Subject: <u>Bid No. 8319-W5, Window Replacement – Worcester East Middle School / WPS</u>

**ADDENDUM NO. 1**

Window and Door Replacement Worcester, East Middle School 420 Grafton Street, Worcester, MA 01604

### ADDENDUM NO. 01 November 08, 2024

PROJECT NO: 2124.17 DATE: 11/08/24

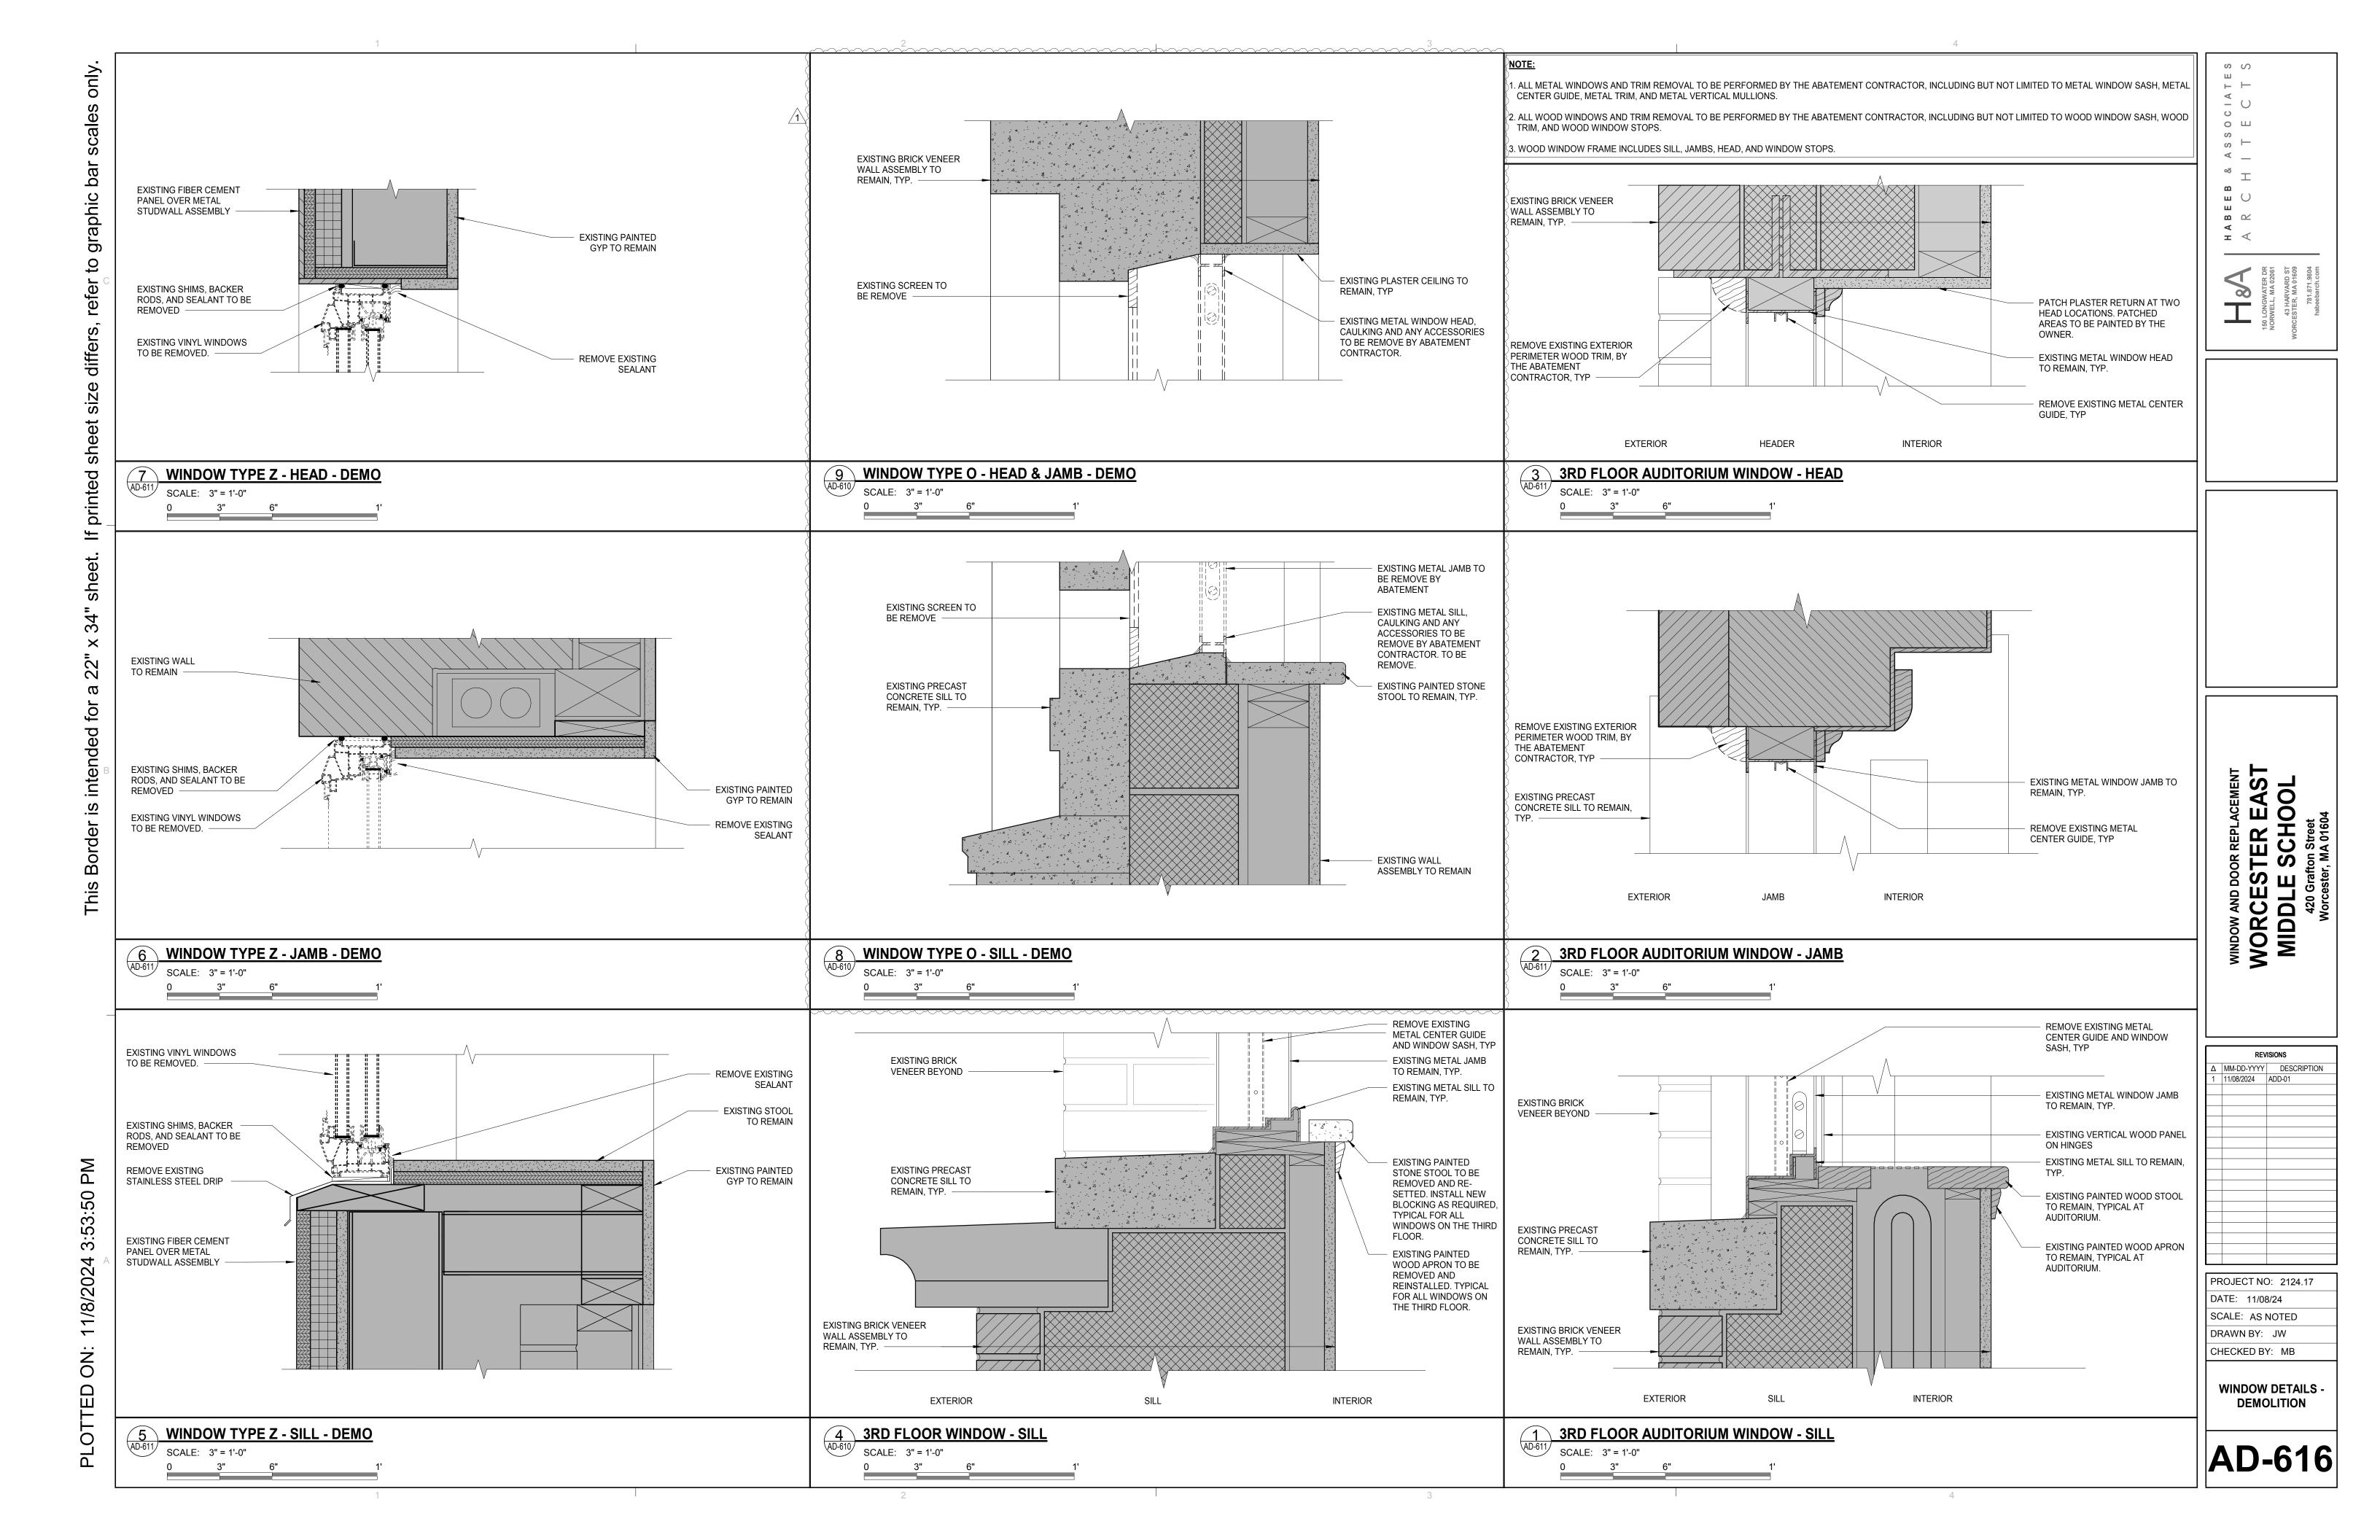
- 1. Sheet G-002:
  - a. Removed the Exception from Section C401.2.1
  - b. Removed mentions of residential energy code under the stretch energy code section.

RESPONSE: Please see the code study on the drawings for 'Fixed Fenestration' on sheet G-002.

WINDOW TYPES

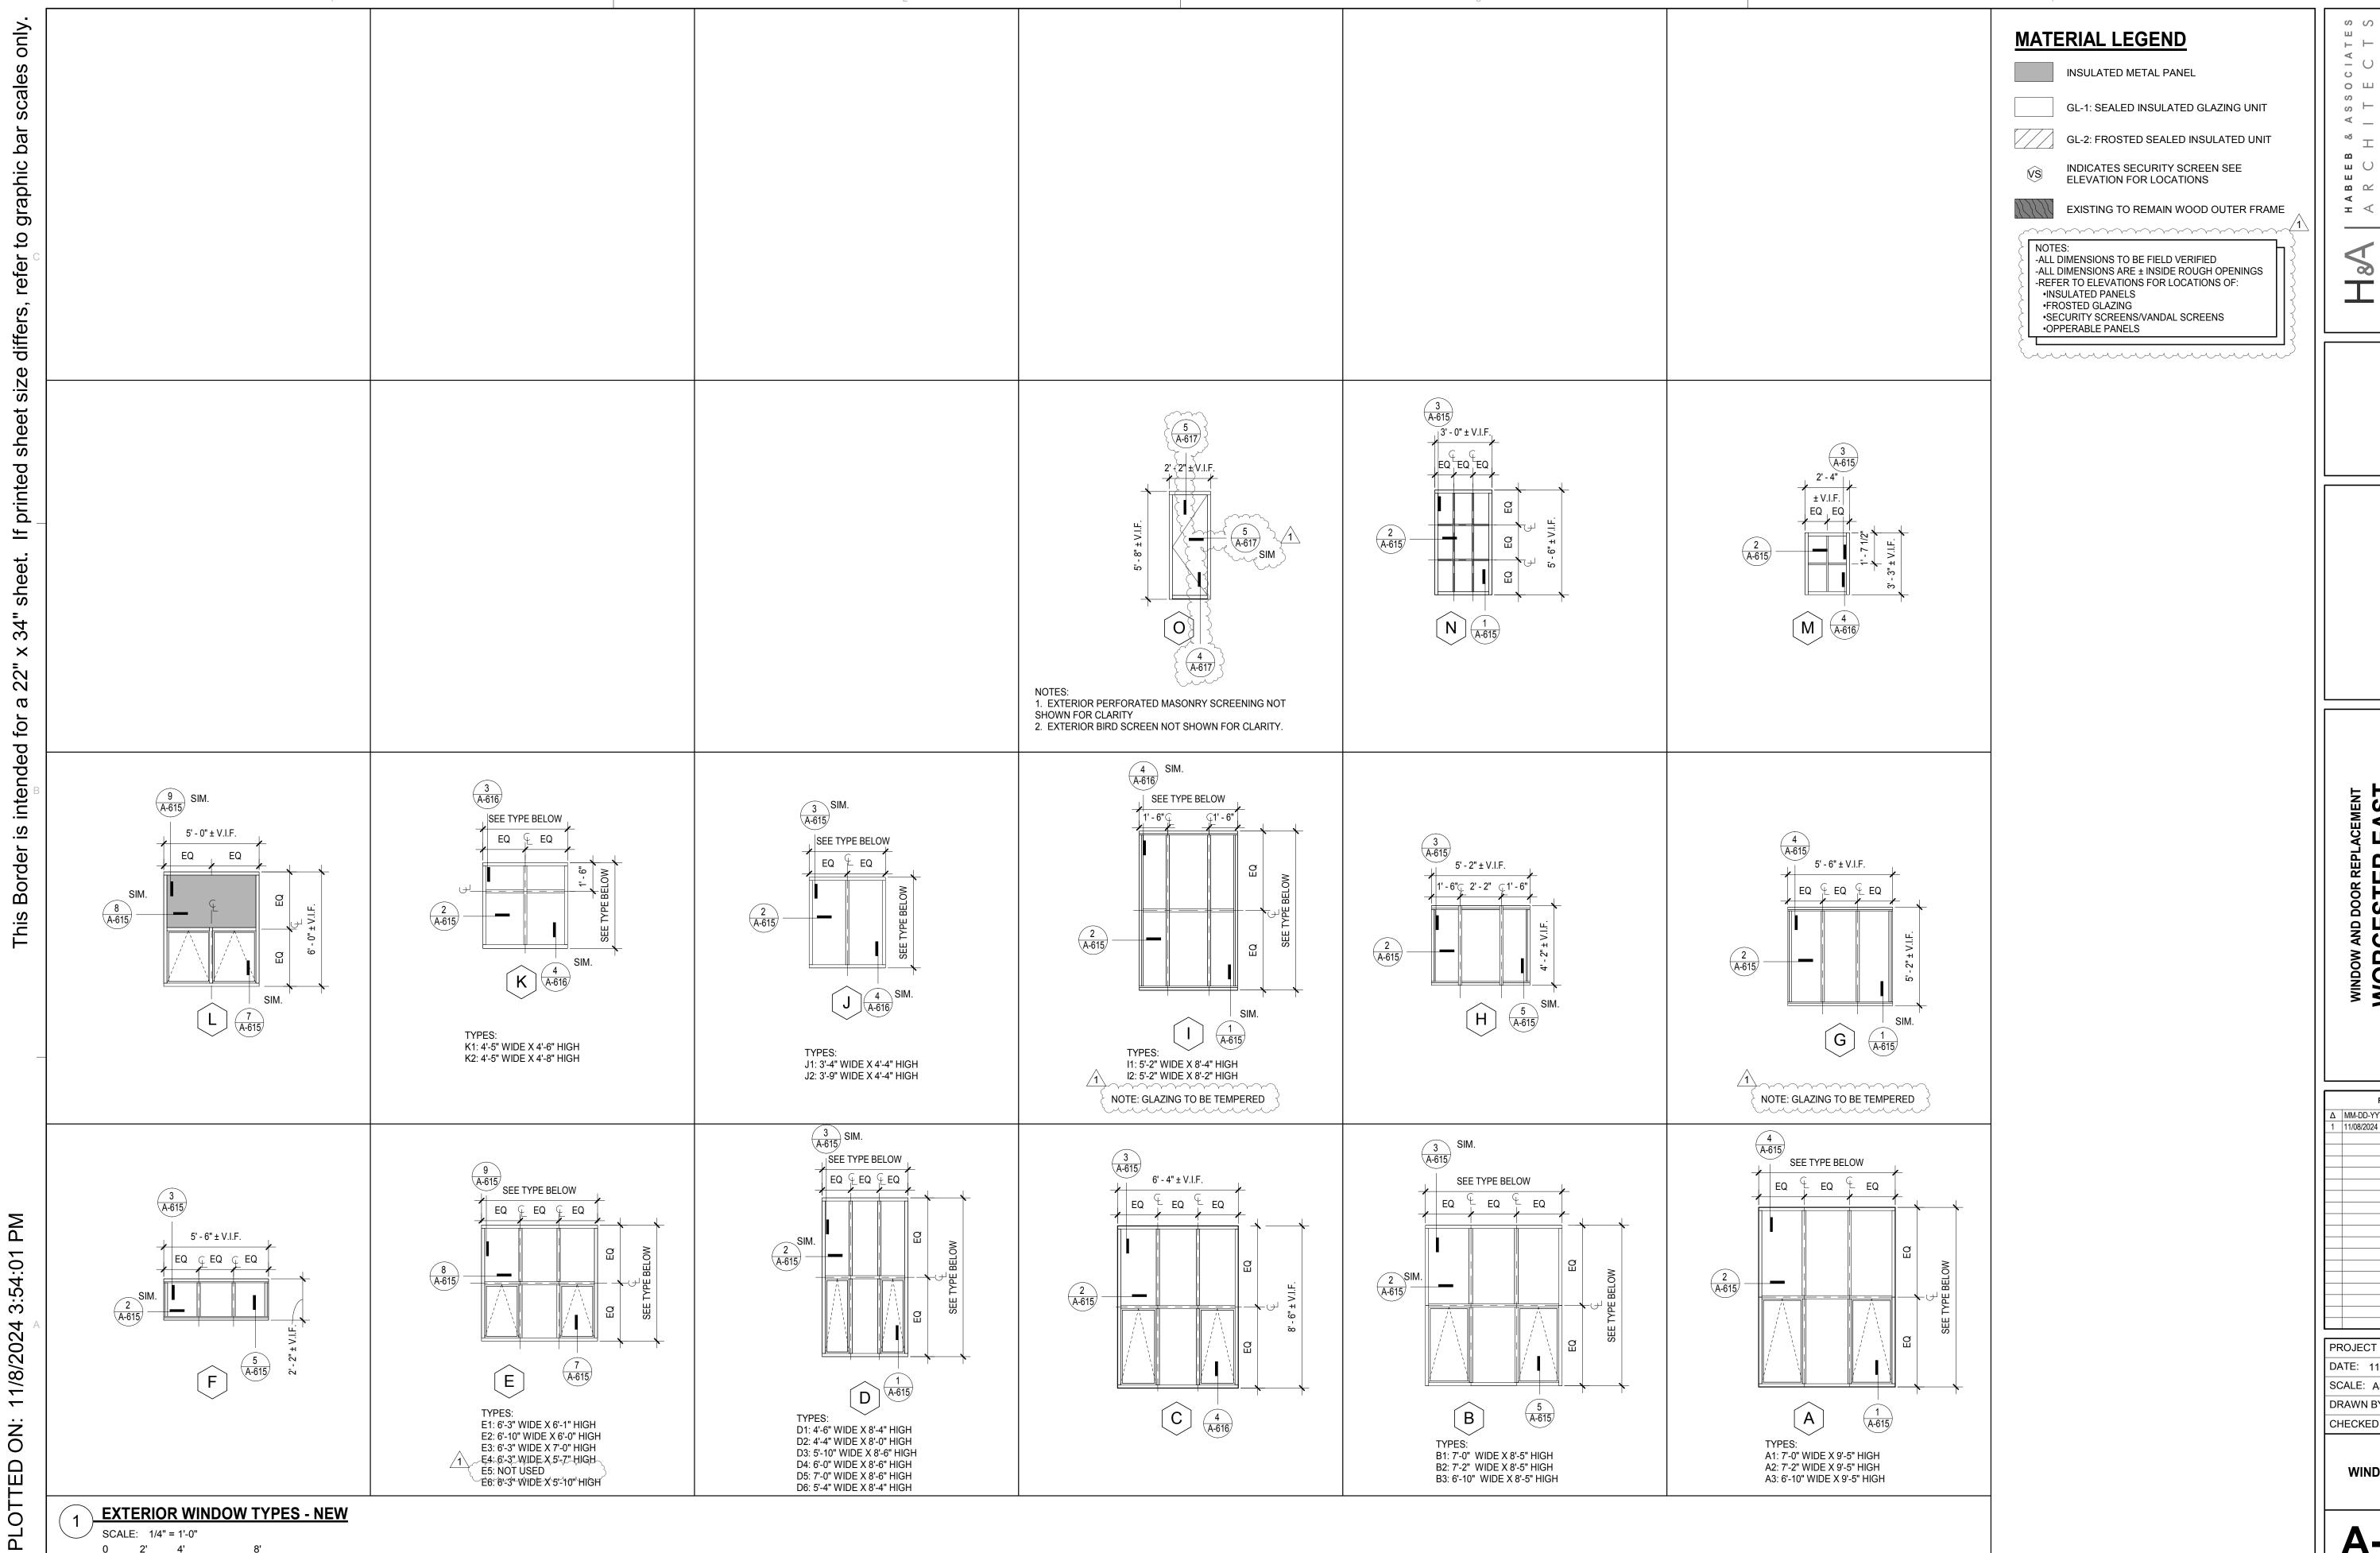
- 11. Sheet A-610
  - a. Updated sheet note
  - b. Window Type E: Removed type E5
  - c. Window Type G: Added note for tempered glazing
  - d. Window Type I: Added note for tempered glazing

- e. Window Type O: Added details
- 12. Sheet A-611
  - a. Updated sheet note
  - b. Window Type T: Updated type from T to T1 and removed type list.
  - c. Window Type W: Added subtype W5

6. QUESTION: Drawing A-610 shows window type H without any operable vents. However, elevation drawings A-201 & A-202 show H windows with operable vents, please clarify?

9. QUESTION: Where are B1 windows located as noted on A-610, none are shown on elevation.

12. QUESTION: What dimensions are W5 windows? They are shown in elevation but not on A-610?

RESPONSE: Operable windows tagged as H should be Type B1. Drawings have been updated.

RESPONSE: B1 windows were incorrectly tagged as H windows. Located on all 4 exterior elevations. Drawings have been updated.

RESPONSE: Dimensions have been added to drawing A-610.

RESPONSE: Tempered glazing is required at stair towers. All windows requiring tempered glazing have been updated on Sheet A-610.
